Application for Works Approval

Works Approval Number W6944/2024/1

Premises Manjali School Wastewater Treatment Plant

Date of report 30 August 2024

Figure 3: Relationship between SAR and EC of irrigation water for prediction of soil structural stability. Note that 1 dS/m = 1,000 µS/cm.

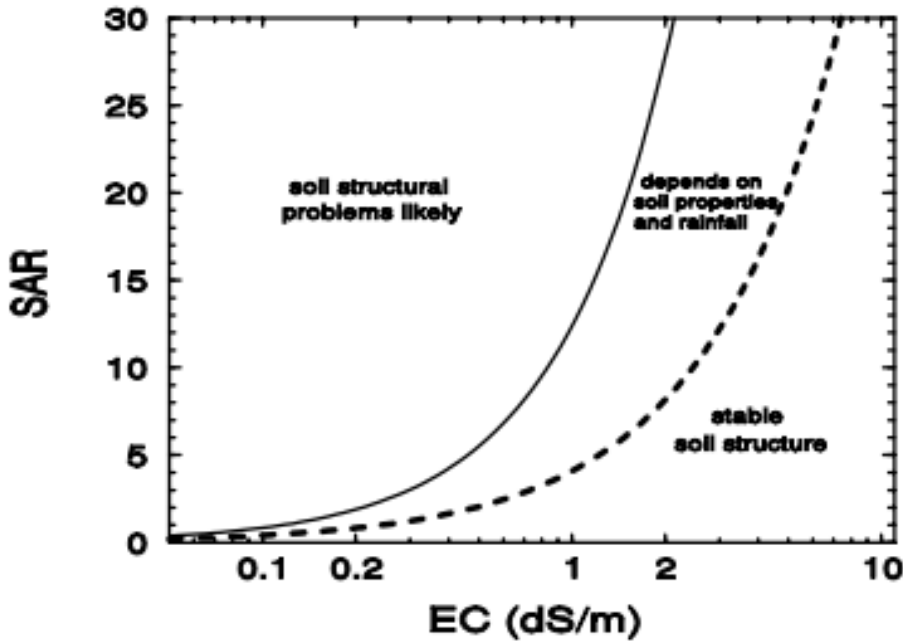
The applicant has submitted a SAR calculation of approximately 3.54. The applicant has submitted a report on water supply assessment for the premises area, which has determined that borehole water sampled has an EC of 1.2 dS/m (1,200 uS/cm). Using Figure 3, there would be a stable soil structure, and the irrigation of RO reject within the blended effluent stream appears to be acceptable.
